Amdt. to ol/change to tech spec consisting of
request to revise the flux/flow trip setpoint
for unit 1 as well as incorporating a
surveillance testing requirement for the
internals vent valves.

Re: Oconee Nuclear Station
Docket Nos. 50-269, -270, and -287

Pursuant to 10CFR50, §50.90, Duke Power Company hereby requests a change in the Oconee Nuclear Station Technical Specifications. The proposed change consists of revising the flux/flow trip setpoint for Oconee Unit 1 as well as incorporating a surveillance testing requirement for the internals vent valves.

FIGURE 2.1-2A

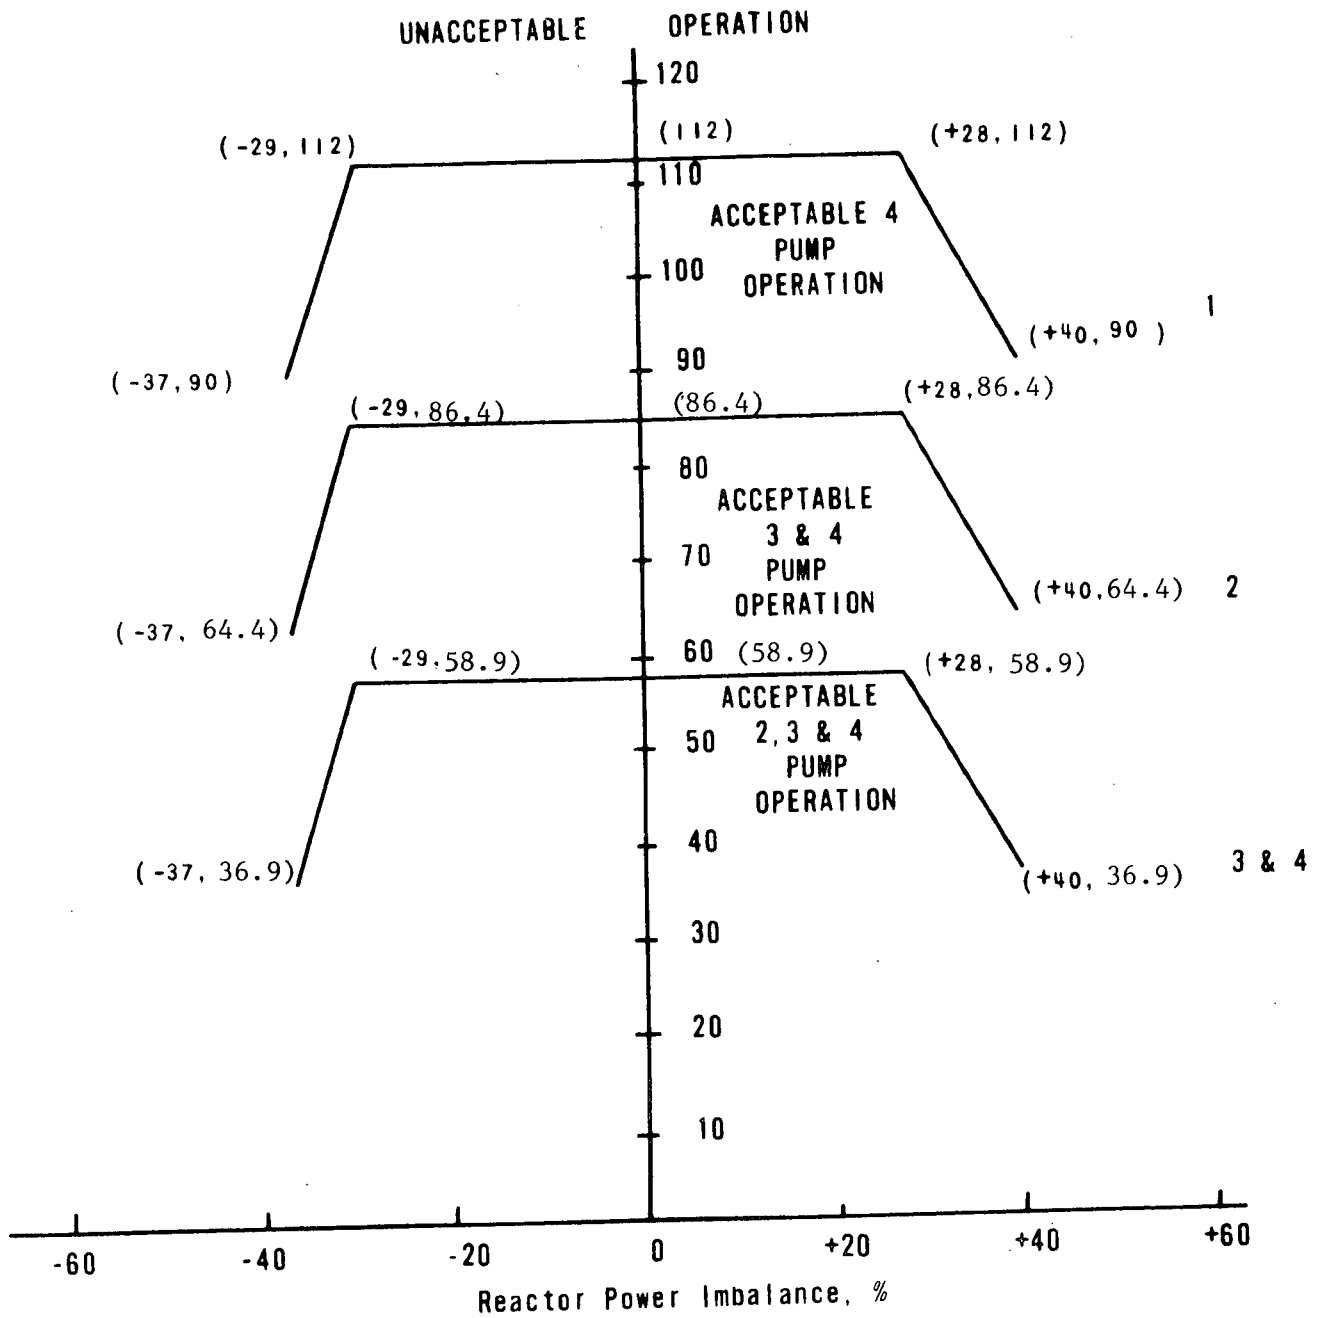
The specified flow rates for Curves 1, 2, 3 and 4 of Figure 2.1-2A correspond to the expected minimum flow rates with four pumps, three pumps, one pump in each loop and two pumps in one loop, respectively.

The maximum thermal power for three-pump operation is 86.4 percent due to a power level trip produced by the flux-flow ratio $74.7 \text{ percent flow} \times 1.07 = 79.9 \text{ percent power}$ plus the maximum calibration and instrument error. The maximum thermal power for other coolant pump conditions are produced in a similar manner.

FIGURE 2.3-2A

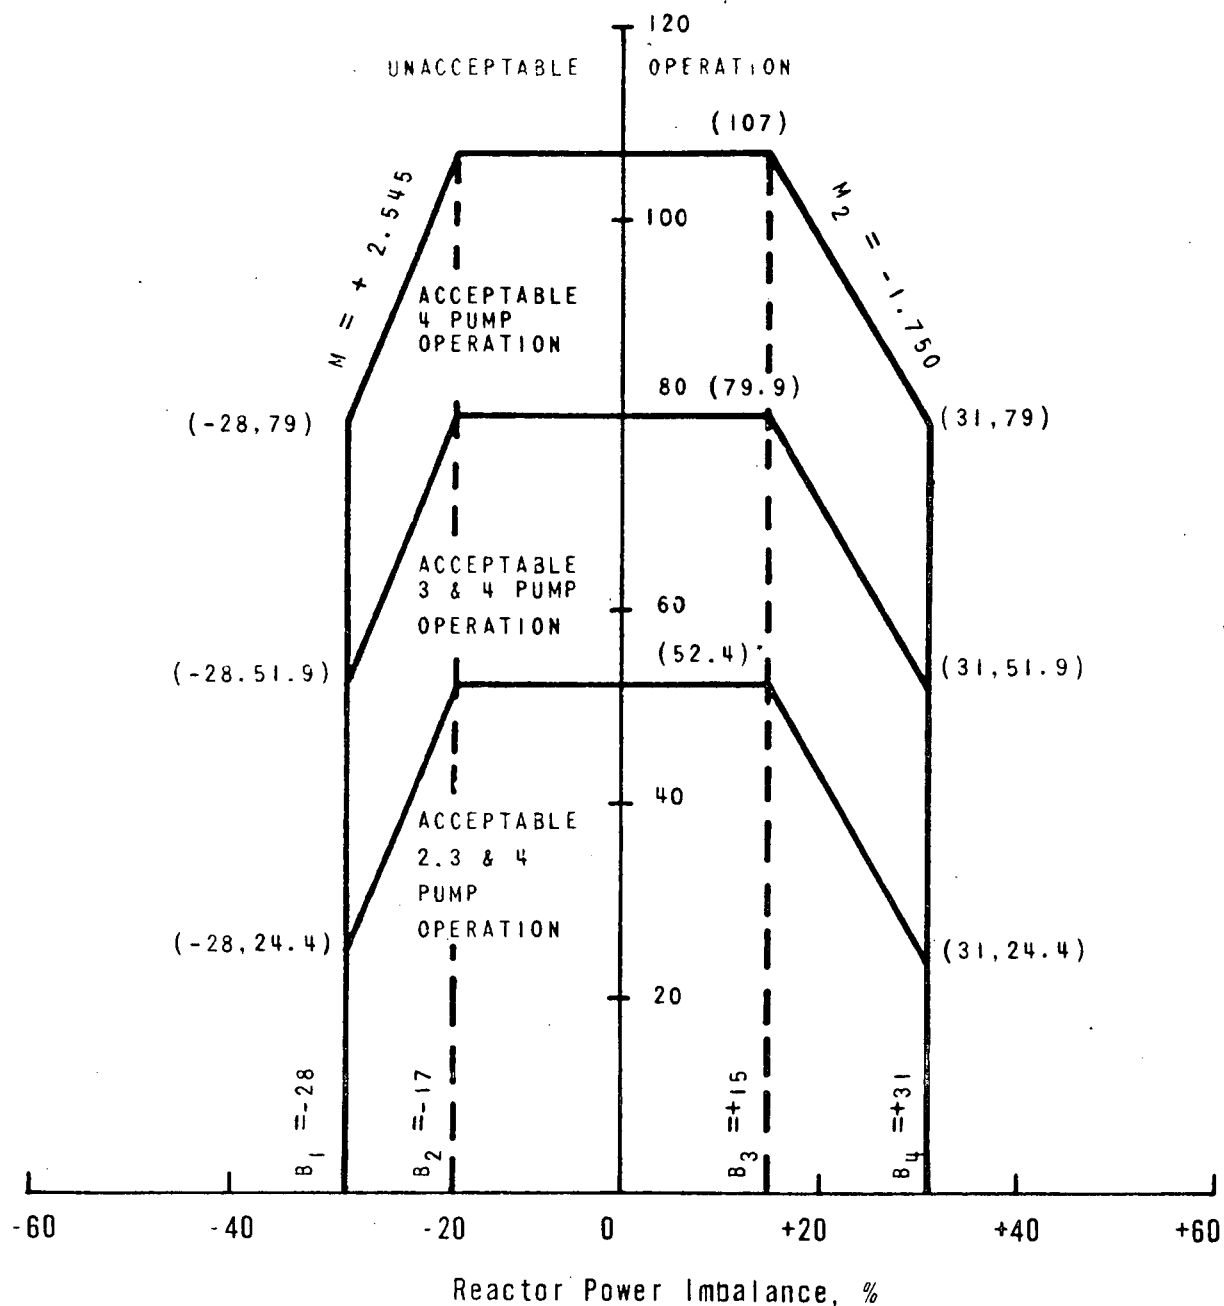
The power-imbalance boundaries are established in order to prevent reactor thermal limits from being exceeded. These thermal limits are either power peaking kw/ft limits or DNBR limits. The reactor power imbalance (power in the top half of core minus power in the bottom half of core) reduces the power level trip produced by the power-to-flow ratio such that the boundaries of Figure 2.3-2A - Unit 1 are produced. The power-to-flow ratio reduces the power

level trip and associated reactor power/reactor power-imbalance boundaries by 1.07% for a 1% flow reduction.

UNIT 1
CORE PROTECTION SAFETY LIMIT
OCONEE NUCLEAR STATION
FIGURE 2.1-2A

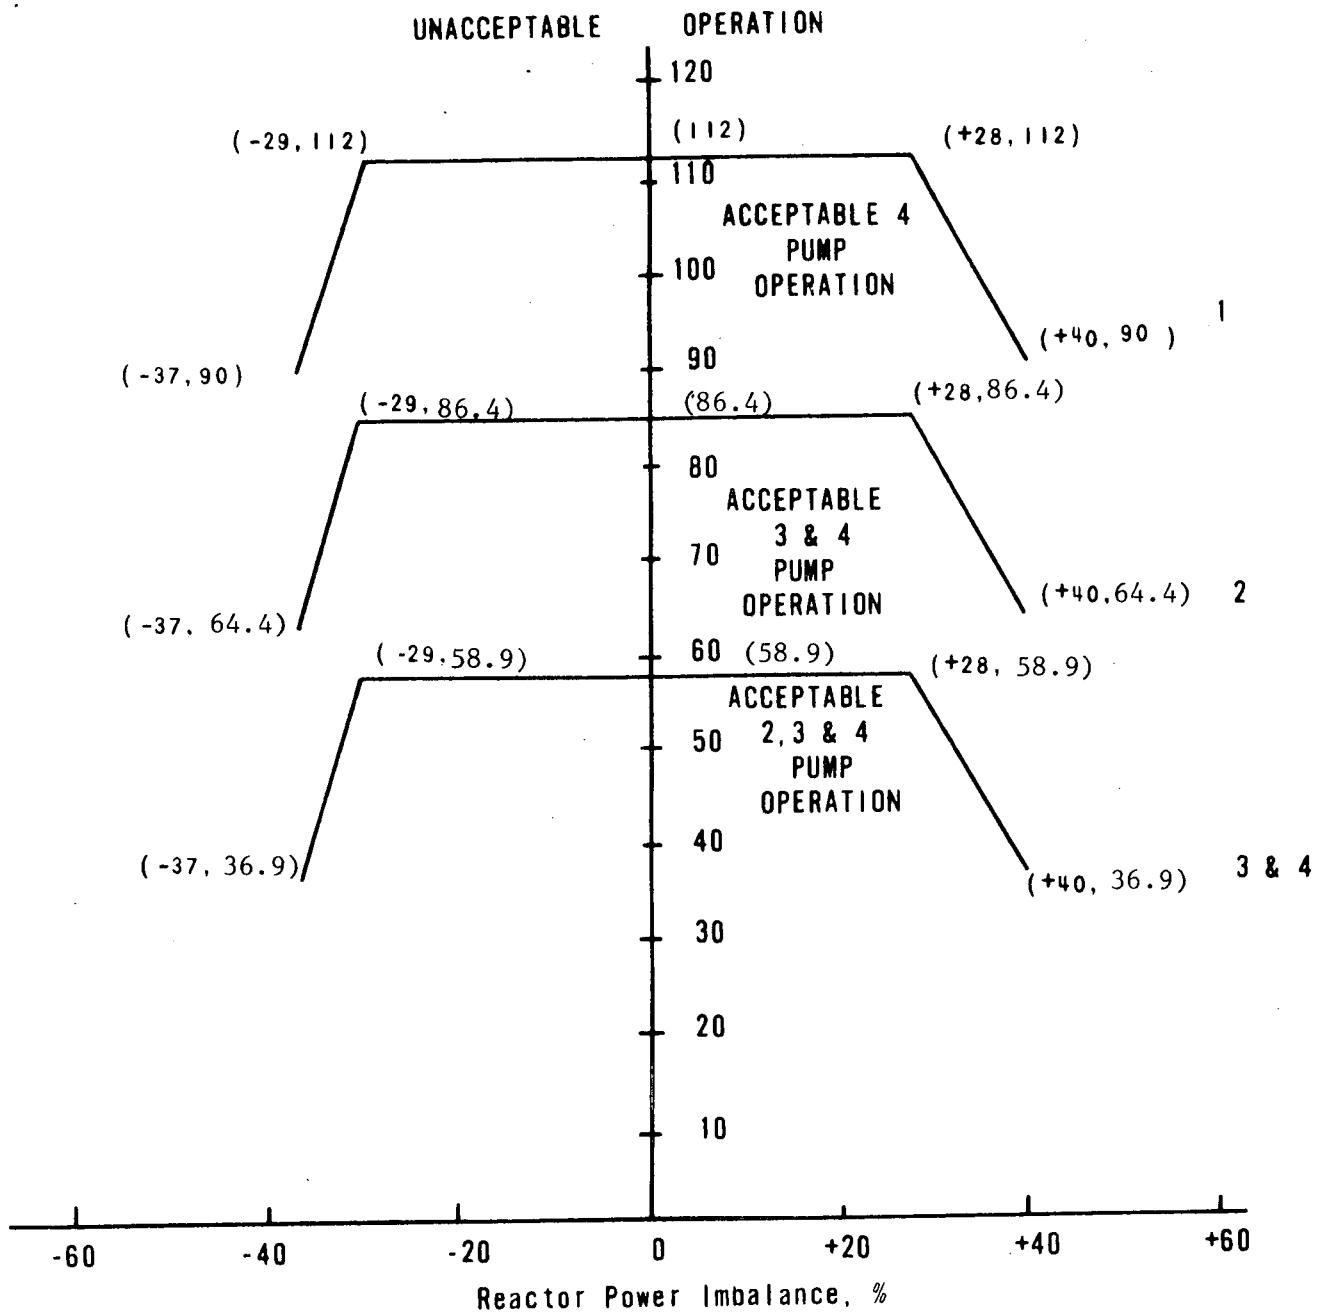
The specified flow rates for Curves 1, 2, 3 and 4 of Figure 2.1-2A correspond to the expected minimum flow rates with four pumps, three pumps, one pump in each loop and two pumps in one loop, respectively.

The maximum thermal power for three-pump operation is 86.4 percent due to a power level trip produced by the flux-flow ratio $74.7 \text{ percent flow} \times 1.07 = 79.9 \text{ percent power}$ plus the maximum calibration and instrument error. The maximum thermal power for other coolant pump conditions are produced in a similar manner.

FIGURE 2.3-2A

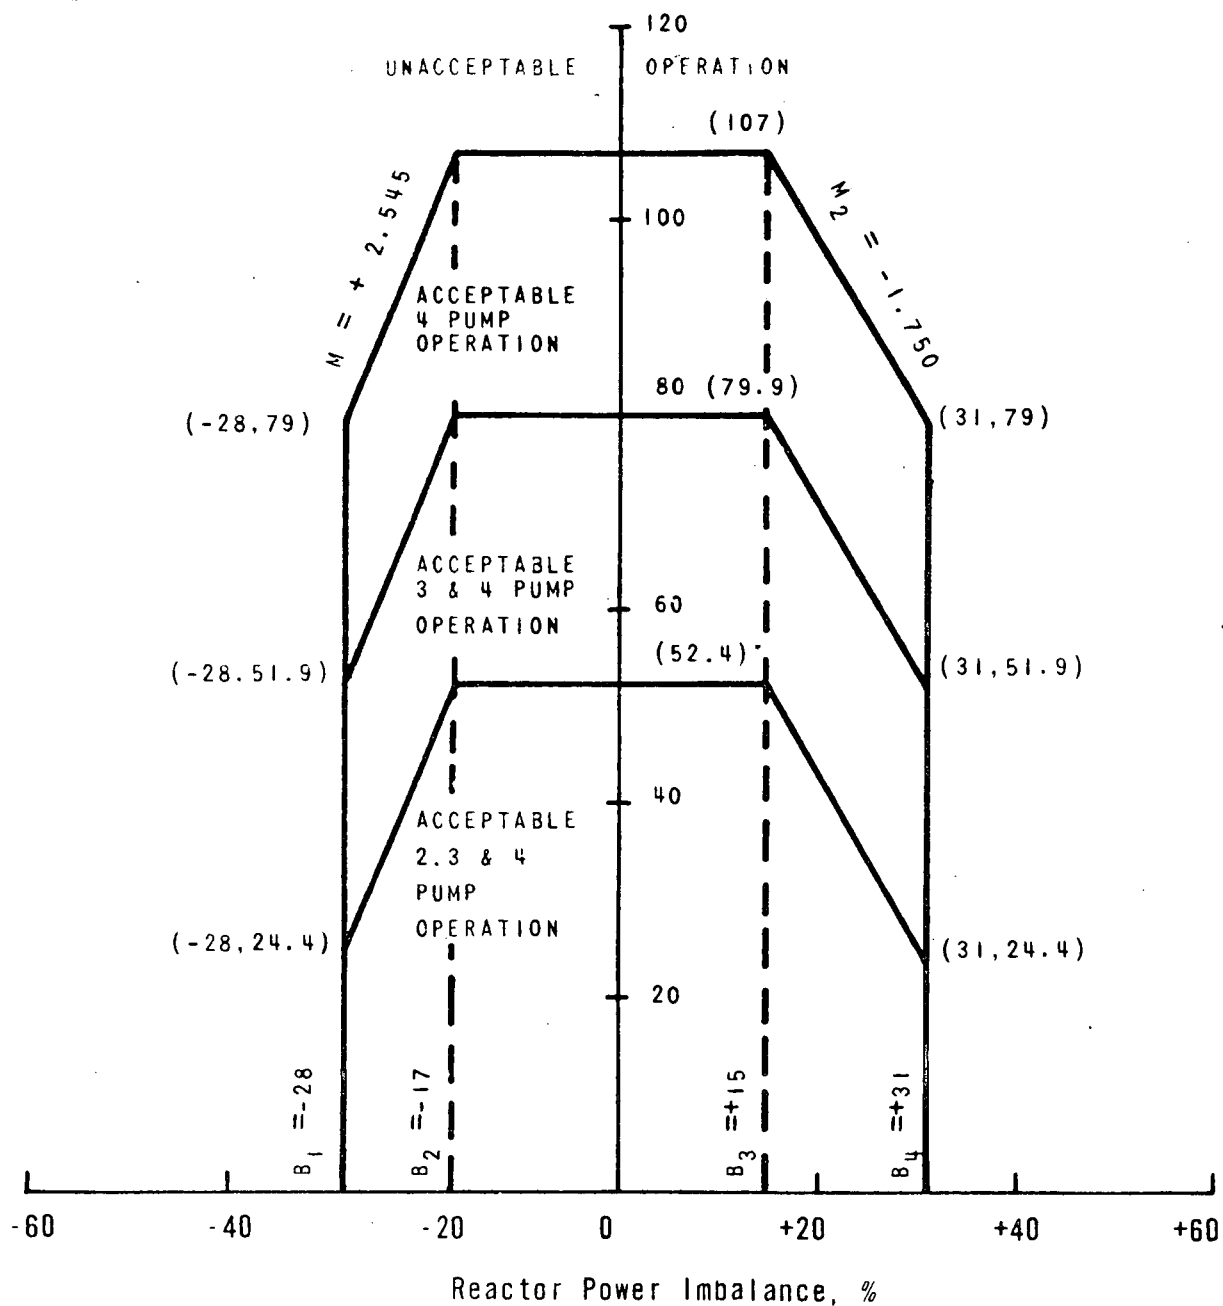
The power-imbalance boundaries are established in order to prevent reactor thermal limits from being exceeded. These thermal limits are either power peaking kw/ft limits or DNBR limits. The reactor power imbalance (power in the top half of core minus power in the bottom half of core) reduces the power level trip produced by the power-to-flow ratio such that the boundaries of Figure 2.3-2A - Unit 1 are produced. The power-to-flow ratio reduces the power:

level trip and associated reactor power/reactor power-imbalance boundaries by 1.07% for a 1% flow reduction.
